# 1997 - 1998 Corvette: Service Bulletin: Loose Lower Front Fascia Valance Panels

**Number:** 73-15-12A

**SUBJECT: LOOSE LOWER FRONT FASCIA VALANCE PANELS (INSTALL ADDITIONAL ADDITIONAL WASHERS)**

**MODELS:** 1997-98 CHEVROLET CORVETTE - BUILT PRIOR TO VIN BREAKPOINT W5127967

**Figure 1**

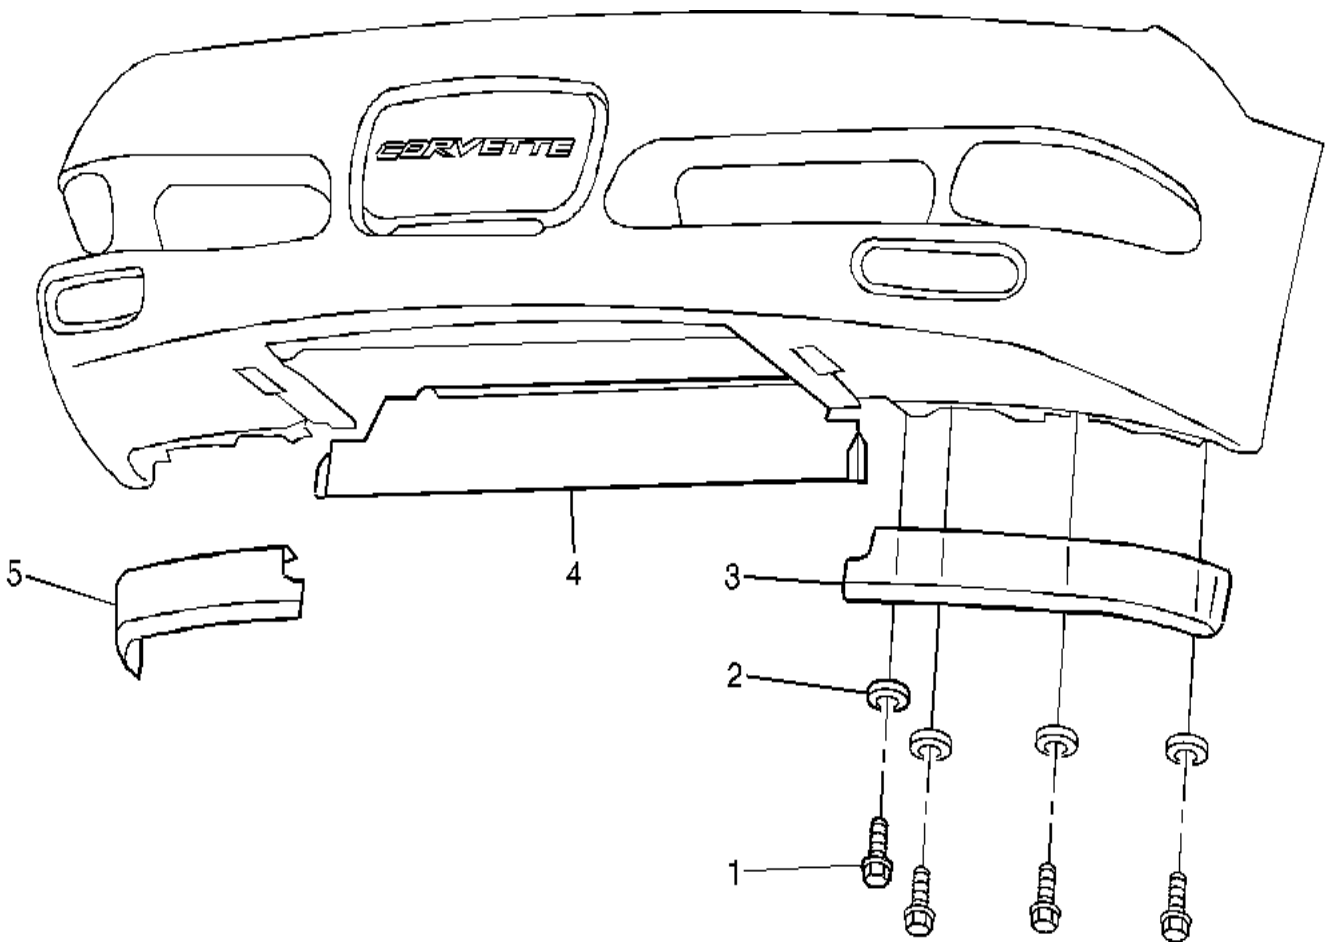
SOME OWNERS MAY COMMENT THAT THE LOWER FRONT FASCIA VALANCE PANELS APPEAR LOOSE.

THE ORIGINAL WASHERS ON THE BOLTS/SCREWS THAT ATTACH THE LOWER VALANCE PANELS TO THE FRONT FASCIA MAY HAVE WORKED THEIR WAY THROUGH THE HOLES IN THE VALANCE PANELS.

ADD ONE ADDITIONAL LARGER FLAT WASHER, P/N 11500365, 25 MM O.D. BY 6.3 MM I.D. BY 2.5 MM THICK (1 IN. O.D. BY 1/4 IN. I.D. BY 3/32 IN. THICK) TO EACH OF THE EIGHT BOLTS/SCREWS (FOUR PER VALANCE PANEL) THAT ATTACH BOTH LOWER VALANCE PANELS TO THE FRONT FASCIA (SEE FIGURE 1). TIGHTEN BOLTS TO 7 N.M (62 LB IN).
